## 1992 No. 133

## ROAD TRAFFIC AND VEHICLES

Traffic Signs (Amendment) Regulations  
(Northern Ireland) 1992

**547.6**

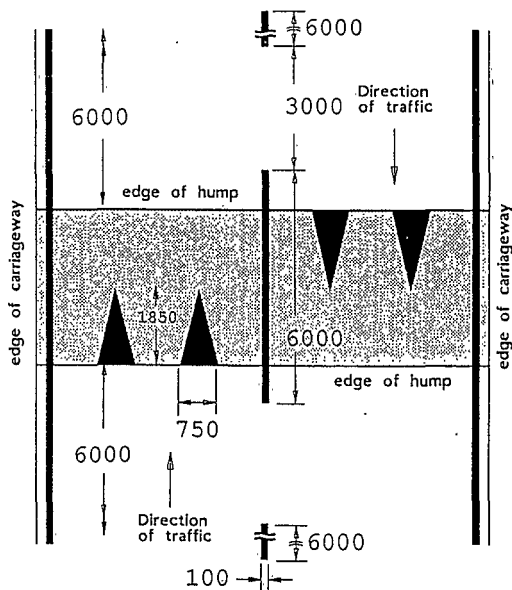
- (i) substituting below diagram 547.5 for the words from “co-incident” to the end the words “located in accordance with regulation 3(2) of the Road Humps Regulations (Northern Ireland) 1992(c)”; and
- (ii) inserting after diagram 547.5 the following diagram 547.6 and the words in and under it—

Plate for use with sign in diagram 543 in a case where a road hump is located in accordance with regulation 3(4) of the Road Humps Regulations (Northern Ireland) 1992 within the limits of a Pelican crossing as indicated in accordance with regulation 3(2) and Schedule 2 to the (Pelican) Pedestrian Crossings Regulations (Northern Ireland) 1989(a).
